EXISTING DRAINAGE AREA MAP

DRN Review completed: MAL 31JUL23  
1. See comments on drainage areas.  
2. See HEC-RAS comments  
3. See HY-8 comments

DGN#	FED. RD. DIV. NO.	STATE	FEDERAL AID PROJECT NO.	HIGHWAY NO.		
CHK DGN#	6	TEXAS	\$PROJNUM\$	CORDOVA RD		
DWG#	DIST.	COUNTY	CONT. NO.	SECT. NO.	JOB NO.	SHEET NO.
CHK DWG#	SAT	GUADALUPE	0915	45	052

# HYDRAULIC DATA SHEET CULVERT A

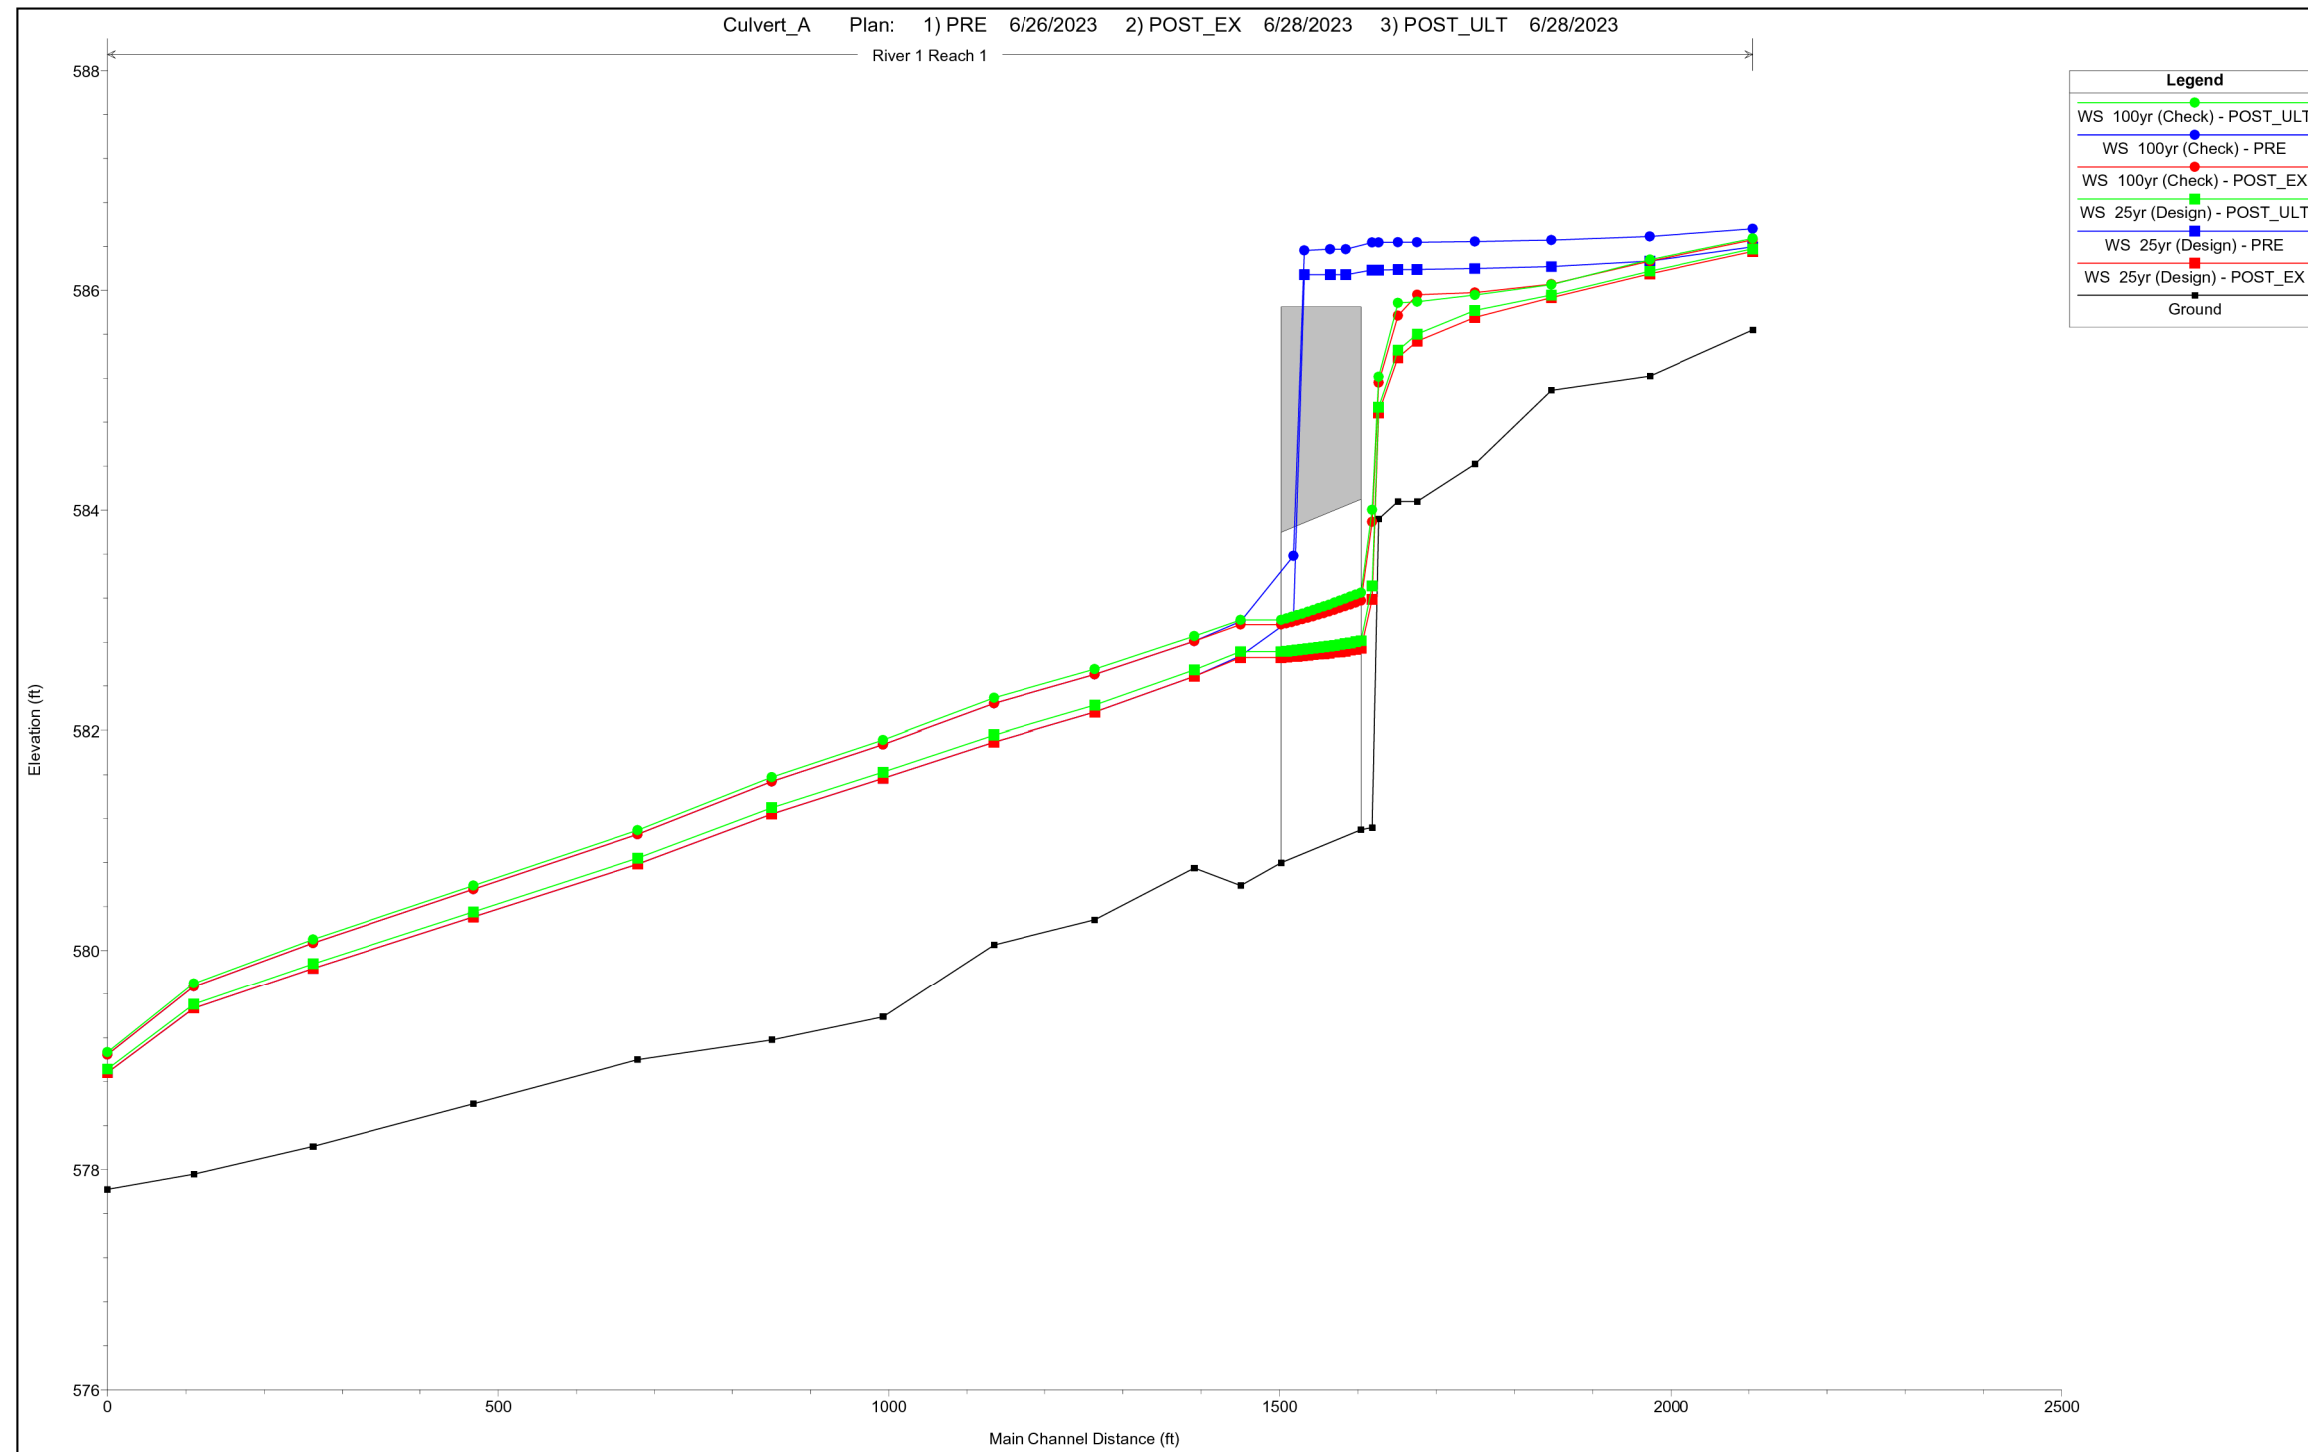
Label streets

Turn on roadway layer

Label streets and culverts

Need to go over model. This doesn't look right. What geometry is shown. You should show all the info in title block, geom, flow, date, plans. Clarify Post Ex. Notes have been added to clarify data presented.

Added.

Added.

Downstream culvert is off the page.

Added.

**HYDRAULIC DATA SHEET  
 CULVERT D EXIST**

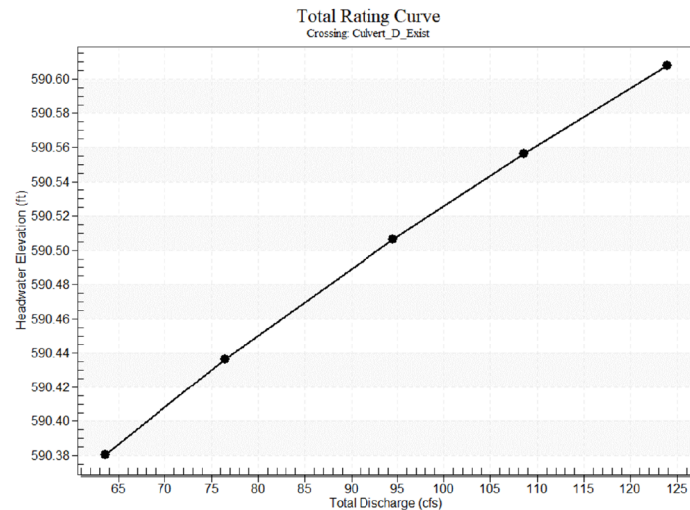
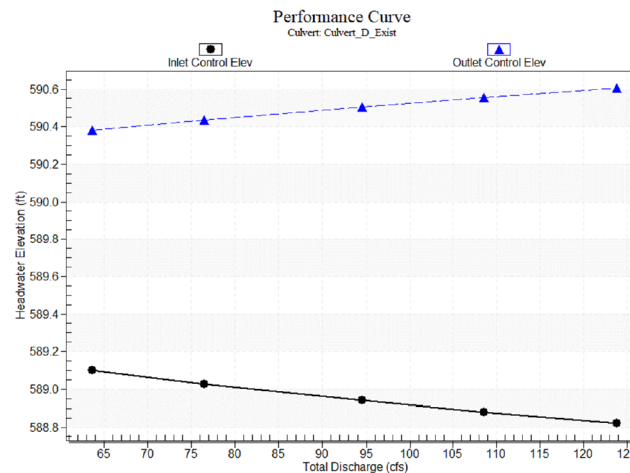
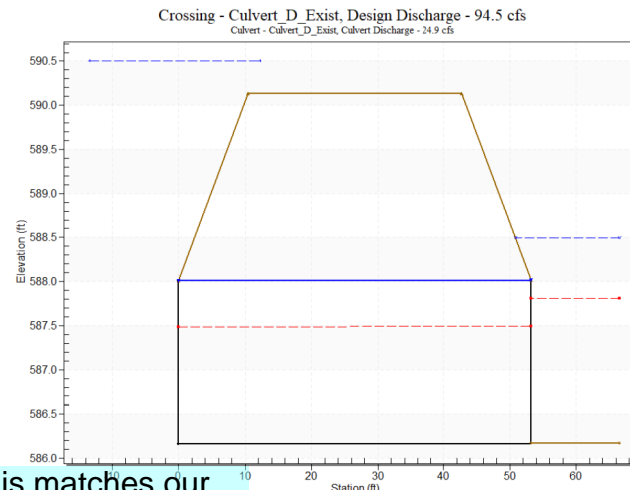
Is this correct, negative slope

This matches our survey elevations.

Agreed. Will add roadway elevations.

HYDRAULIC DATA SHEET CULVERT F-1 PROP					
DGN:	FED. RD. DIV. NO.:	STATE:	FEDERAL AID PROJECT NO.:	HIGHWAY NO.:	
CHK DGN:	6	TEXAS	\$PROJNUM\$	CORDOVA RD	
DWG:	DIST.:	COUNTY:	CONT. NO.:	SECT. NO.:	JOB NO.:
CHK DWG:	SAT	GUADALUPE	0915	45	052

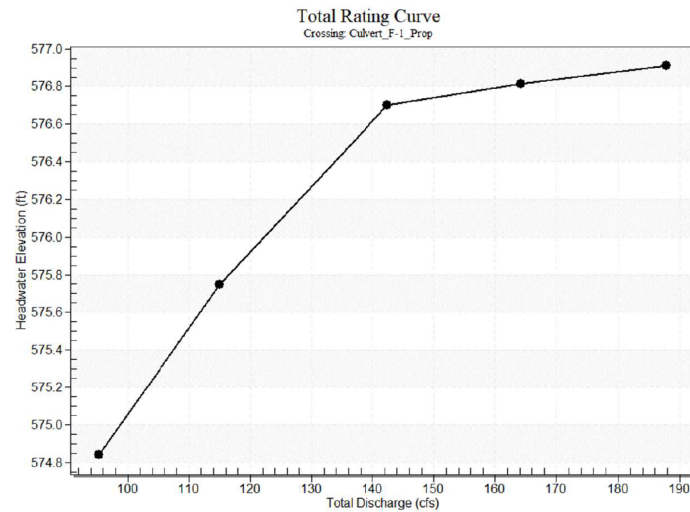
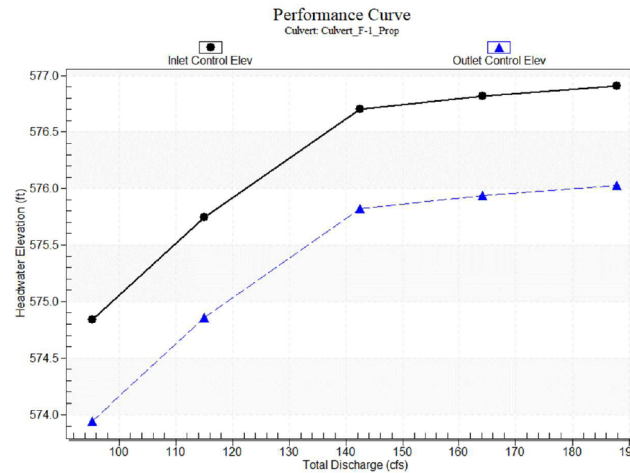
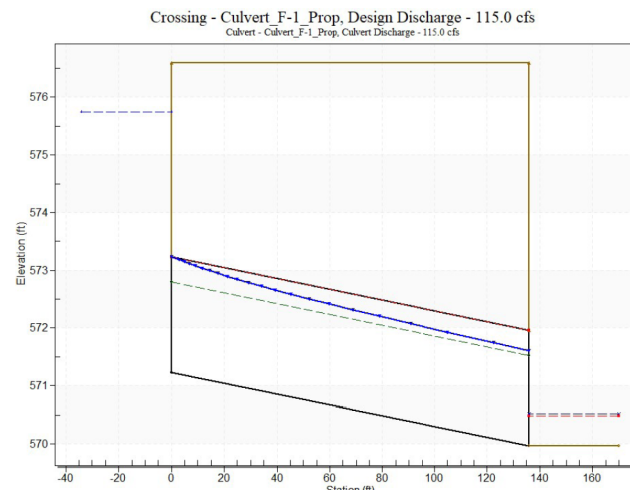
Is this correct?

Needs to be irregular with coordinates. Constant Roadway is not allowed.

Agreed. Will add roadway elevations.

Design flow does not overtop roadway, which is the design standard. Since this is a cross culvert, it is acceptable that the system is under pressure. However, we are upsizing to reduce velocity.

Will add capacity.

Agreed. Capacity will be added to reduce velocities.
